SECTION 009113 – ADDENDUM TWO

- A. Project Name: 22034.03 Meridian High School Baseball/Softball Rebid
- B. Owner: Meridian Public School District, 1019 25th Avenue, Meridian, MS 38391
- C. Architect: Dale | Bailey, an Association, One Jackson Place, Suite 250, 188 East Capitol Street, Jackson, MS 39201-2100
- D. Architect Project Number: 22034.03
- E. Date of Addendum Two: 18 August 2023

1 RENOVATION SITE PLAN - ALTERNATE
E004 Scale: 1" = 30'-0"

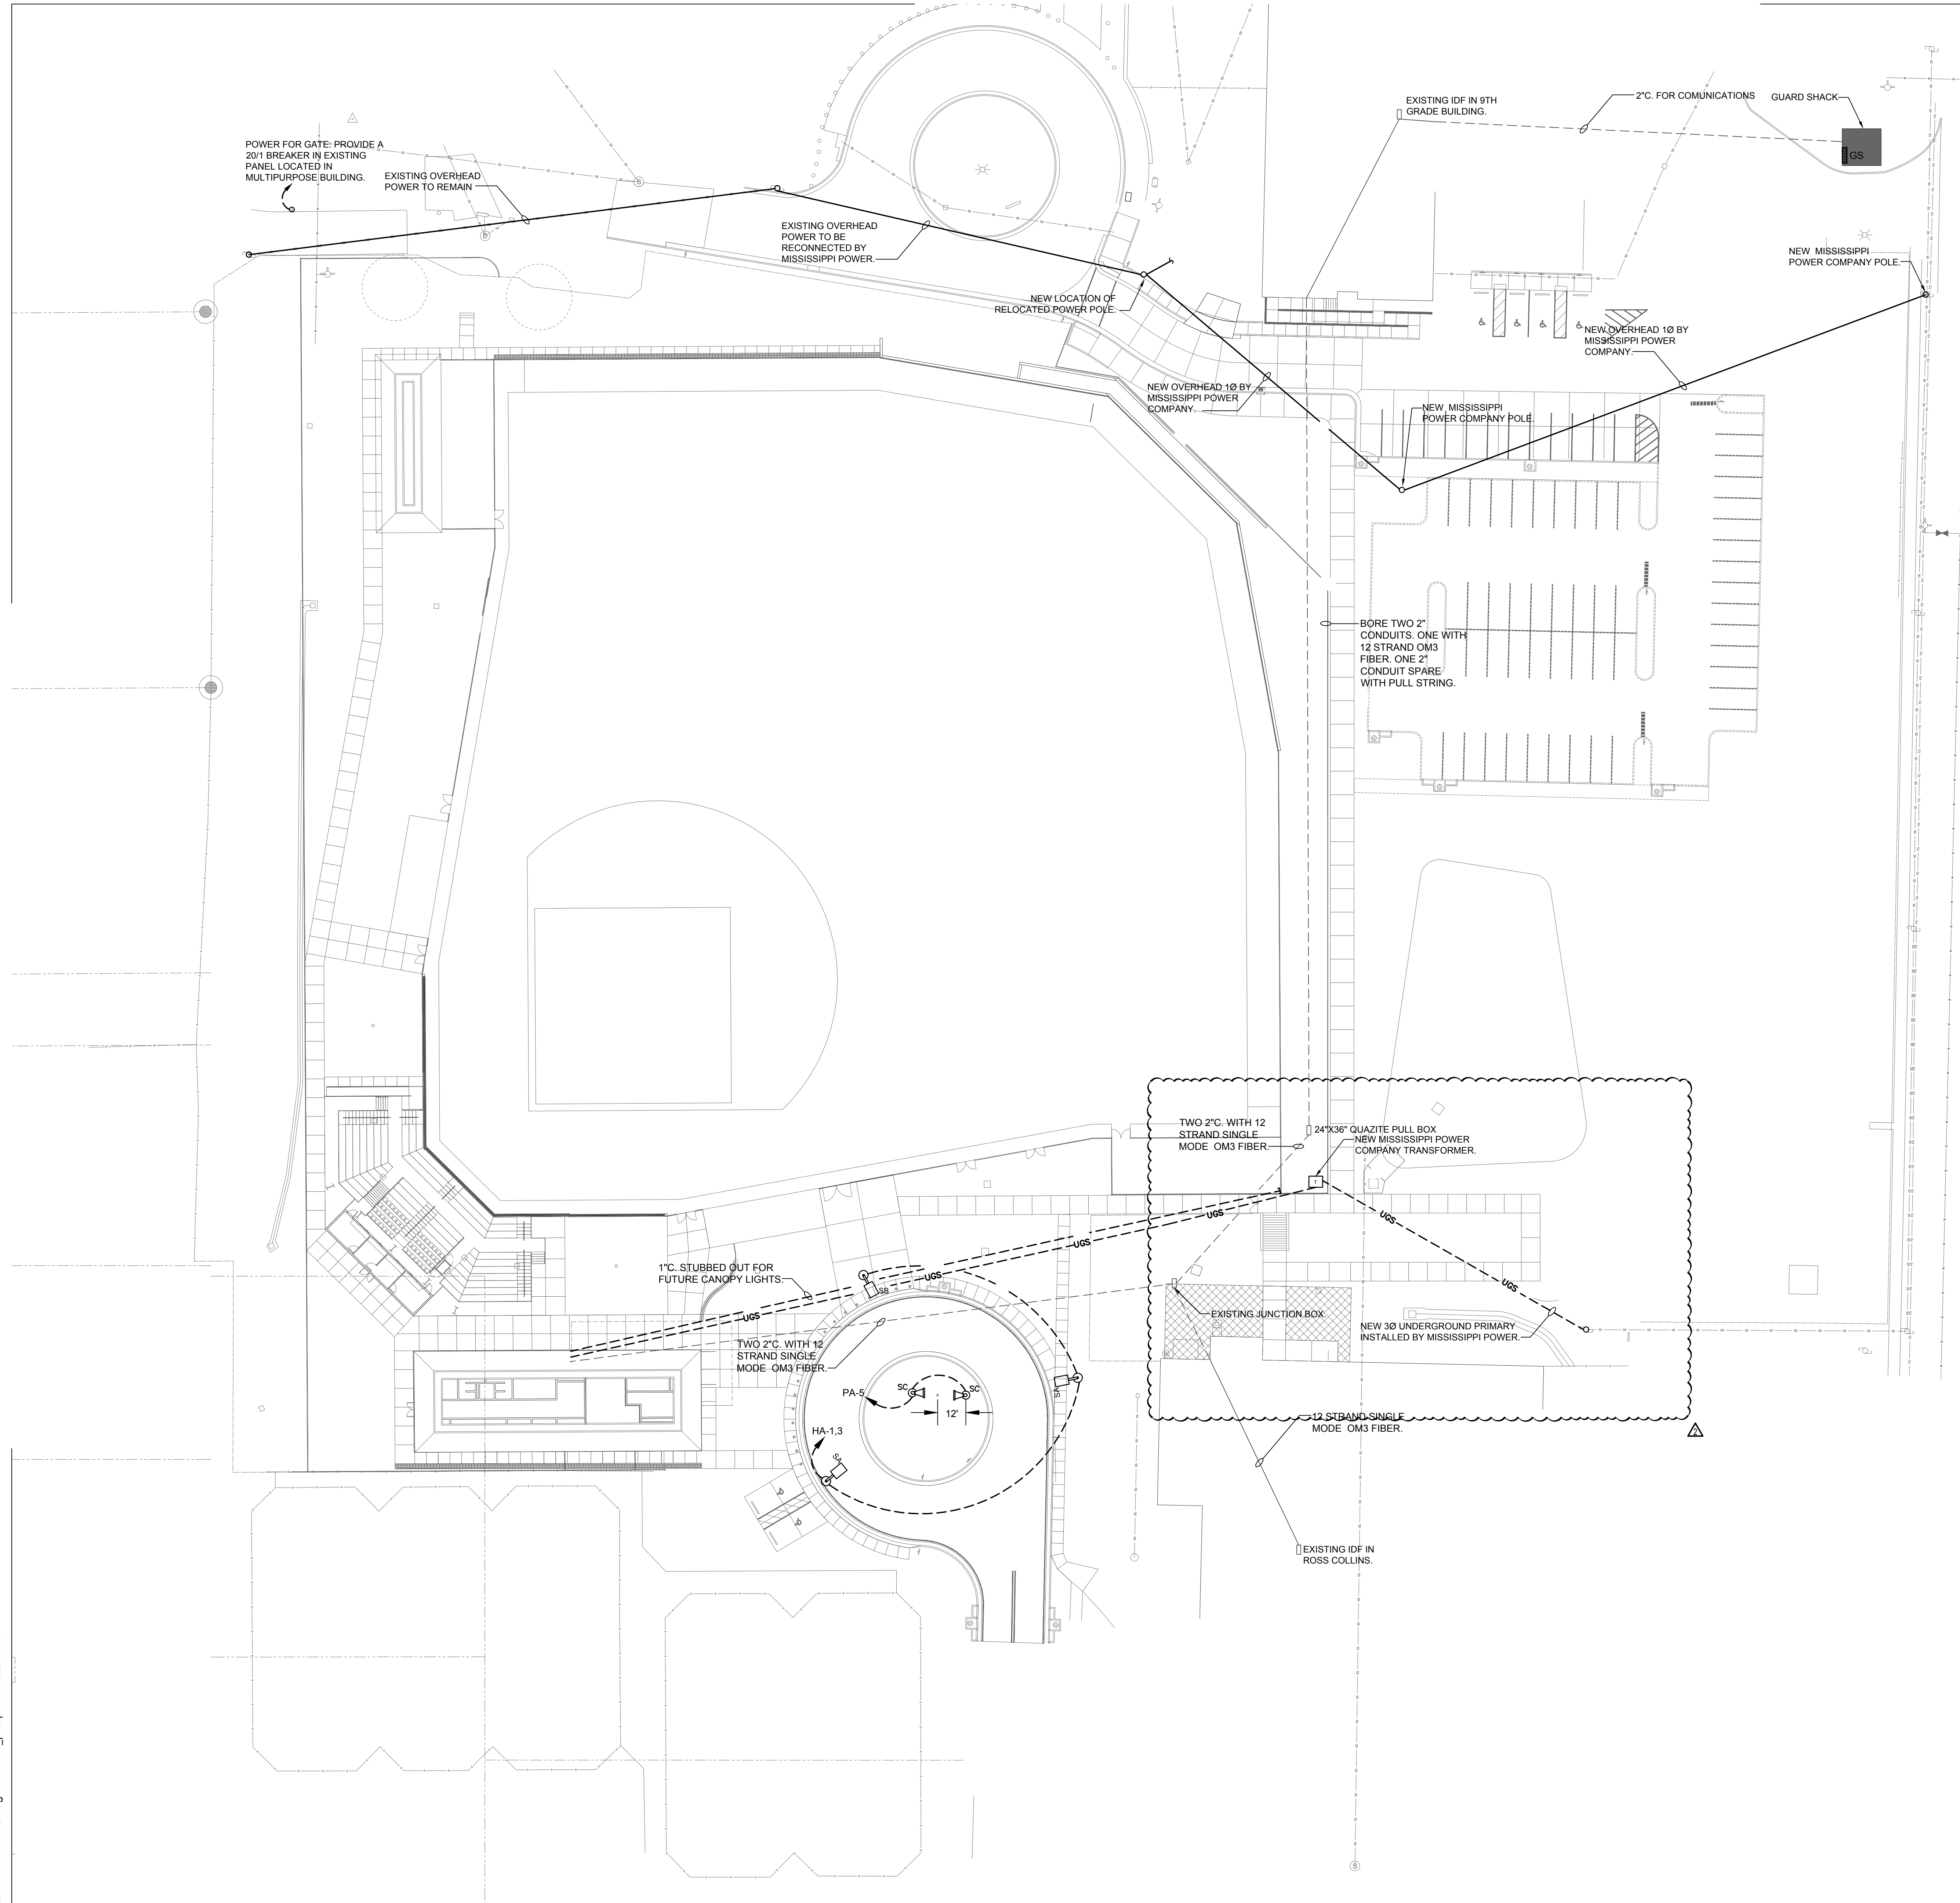
- H. Electrical Sheet E-004 – Meridian High Baseball Field Renovation Site Plan - Alternate (Reissued). Delete this sheet in its entirety and replace it with the attached. Relocated transformer.
